**THE CITY OF KEY WEST
PLANNING BOARD**

Staff Report

Agenda Item: **Major Development Plan – 3201 Flagler Avenue (RE# 00052870-000100)** - A request for a major development plan approval to reconstruct a two-story mixed-use commercial and residential structure with landscape waivers on minimum landscape percentage, street frontage, interior, and perimeter landscaping on property located within the Limited Commercial (CL) Zoning District pursuant to Chapter 108, Section 108-91, and Article III through IX, Chapter 122, Article IV, Division 4, Subdivision II, and Section 122-28 of the Land Development Regulations of the Code of Ordinances of the City of Key West, Florida.

Proposed Site Plan

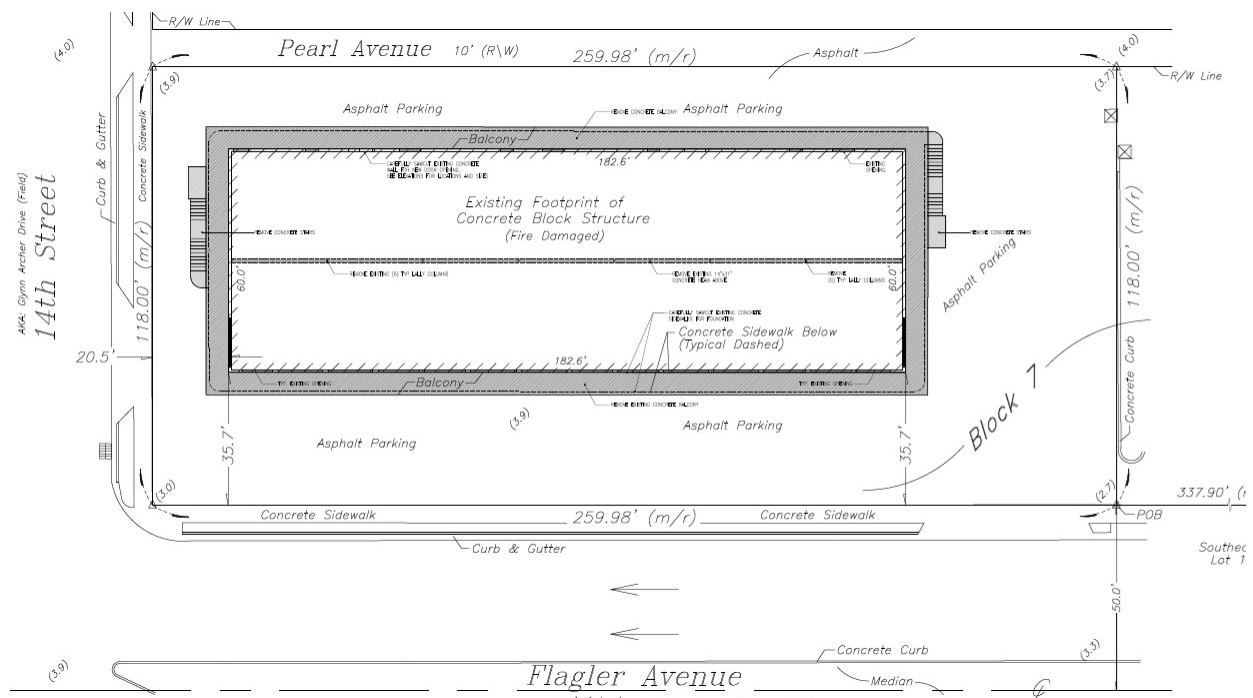
Dimensional Requirements	Required		Existing		Proposed		Complies
Max. Density	16 du/ac	11.27	14		14		N*
Max. FAR	0.8	24,541.60	0.7	21,230	0.7	21,210	Y
Max. Height	40'		30'		25'-8"		Y
Max. bldg coverage	40%	12,270.80	46.5%	14,262	46.5%	14,262.00	N*
Max. ISR	60%	18,406.20	100%	30,677	98.5%	30,222.00	N*
Front setback	25' or 20% of lot depth	25'	29'-8"		29'-8"		Y
Rear setback	25' or 20% of lot depth	25'	16'-2"		16'-2"		N*
Side Setback	15' or 10% of lot width up to 20' max, whichever is greater	20'	46'-1"		46'-1"		Y
Side street setback	20'		9'-8"		9'-8"		N*

*Per Sec. 122-28, structure may be replaced at its nonconforming density, location, and three-dimensional building envelope.

Proposed Landscape & Drainage Plan

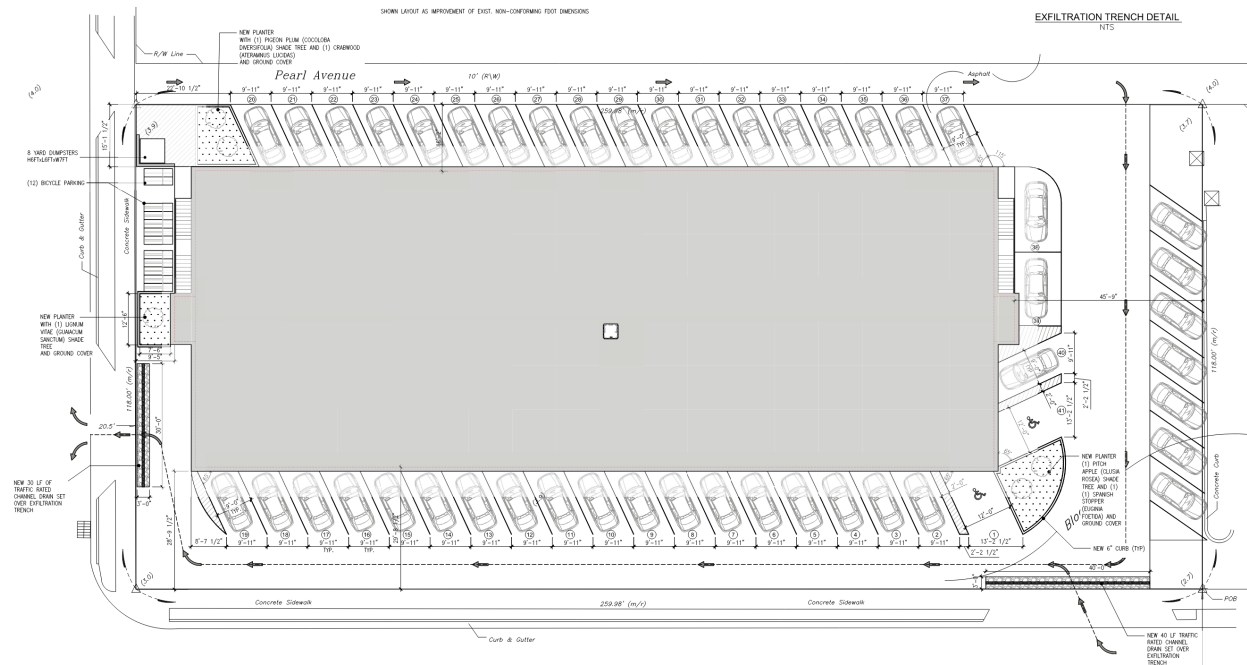
access/egress considerations. / Sec. 108-318. - Separation of vehicles, bicycles and pedestrians.		
Article V: Open Space, Screening & Buffers		
Sec. 108-346. - Open space, landscaping and removal of exotic vegetation.	The applicant proposes landscaping improvements with approximately 450 sq. ft. of new landscaping where none exists currently.	Build-back permitted per Sec. 122-28.
Sec. 108-352. - Reducing landscape and/or bufferyard requirements.	30' required street frontage landscape buffer.	Build-back permitted per Sec. 122-28.
Article VI: Landscaping		
Sec. 108-411. - Landscape plan approval.	The conceptual landscape plan was reviewed and approved by the Tree Commission on August 19, 2025.	Yes.
Sec. 108-413. - Requirements along street frontage.	The site requires a landscape strip along the frontage at least 30' in width, with at least 120 plant units per 100 linear feet.	Build-back permitted per Sec. 122-28.

Sec. 108-416. - Other landscape requirements for nonvehicular use areas.	The site requires 4 trees for every 2,000 sq. ft. of nonvehicular open space.	Build-back permitted per Sec. 122-28.
Sec. 108-452. - Required sight distances for landscaping adjacent to public rights-of-way and points of access.	N/A	N/A
Sec. 108-481. - Specifications for plant materials.	If palms are used, they shall constitute no more than 25 percent of total tree requirements	Yes.
Sec. 108-517. - Waivers or modifications.	Per Section 108-517, the Planning Board may waive or modify the standards of Chapter 108 Article VI upon a finding that the modification meets the criteria outlined in Section 108-517. Staff has reviewed the application and found it consistent with these criteria.	Yes, build-back permitted per Sec. 122-28.
Article VII: Off-Street Parking and Loading		
Sec. 108-571	No change is proposed to the existing parking configuration totaling 48 spaces.	Build-back permitted

1. The proposed development shall be consistent with the plans by WSA Architecture, dated April 11, 2025, including the site plan sheet with revision date July 29, 2025.
2. The proposed development shall be consistent with the drainage plan by Northstar Engineering LLC signed August 25, 2025.
3. Final landscape plan approval is required from the Tree Commission or the Urban Forestry Manager prior to City Commission.
